Economic Commission for Europe**Inland Transport Committee****World Forum for Harmonization of Vehicle Regulations****Working Party on General Safety Provisions****112th session**

Regulation No. 43 (Safety glazing)**Proposal for Supplement 6 to the 01 series of amendments to Regulation No. 43 (Safety glazing)****Submitted by the expert from the European Association of Automotive Suppliers***

Annex 21, Figure 2a, amend to read:

"Figure 2a:

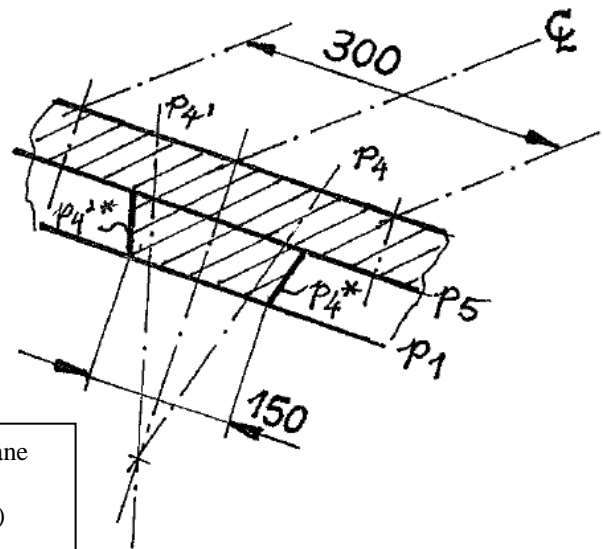
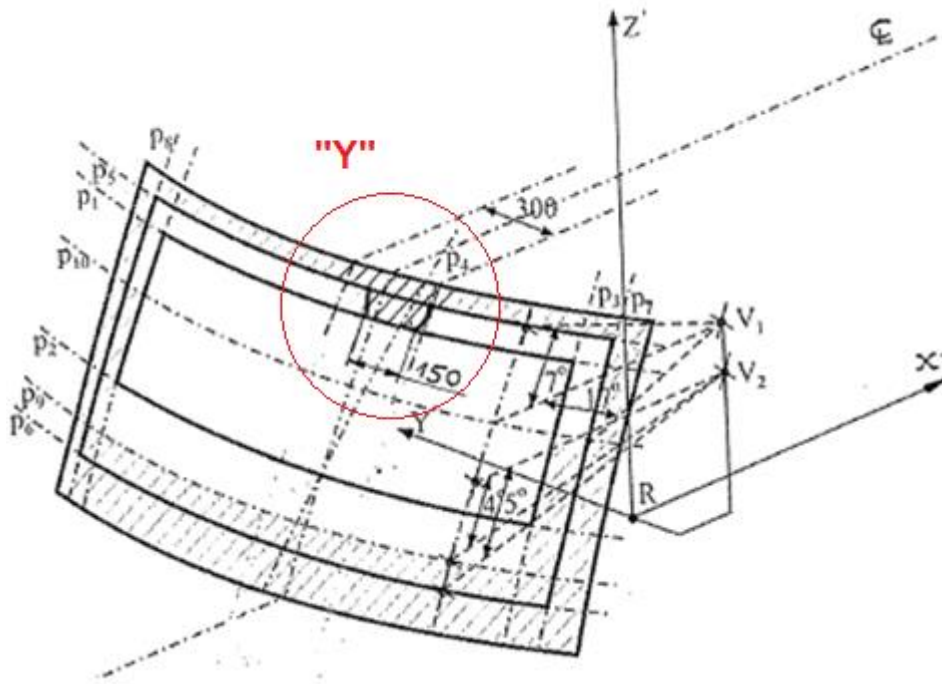
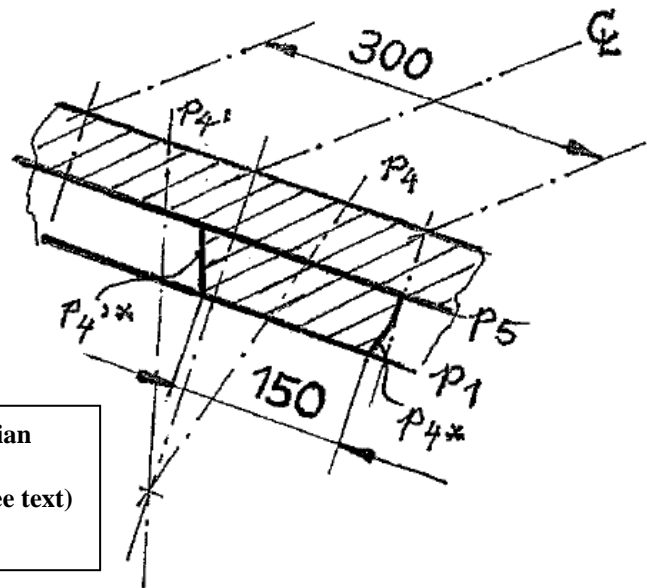
The text reproduced below was prepared by the expert from the European Association of Automotive Suppliers (CLEPA) to amend Figure 2a of Annex 21 to better reflect the meaning of paragraph 2.4.2.2. of Annex 21, mainly to clarify the lateral limits of any opaque obscuration in this area. The modifications to the current text of UN Regulation No. 43 are marked in bold characters for new and strikethrough for deleted characters.

CLEPA proposes the modification of Figure 2a into two figures; one symmetrical example and one asymmetrical example, to reflect the meaning of paragraph 2.4.2.2., mainly to clarify the lateral limits of any opaque obscuration in this area. These lateral limits are parallel to the traces of planes 4 and 4' but not allowed to go beyond the 300 mm overall limit. On the trace of plane 1, it is a boundary width of 150 mm which is allowed to be centred to the longitudinal median plane of the vehicle (C_L) or this 150 mm segment is allowed to be moved to the right or left of C_L . The boundary width on the trace of plane 5 is given by the parallels ($p4^*$ and $p4'^*$) to the traces of planes 4 and 4' not exceeding the overall limit of 300 mm.

Reduced test area "B" (example of a left-hand steering control vehicle) - upper obscuration area as defined in paragraph 2.4.2.2.

Detail "X": example symmetric to C_L

Detail "Y": example asymmetric to C_L
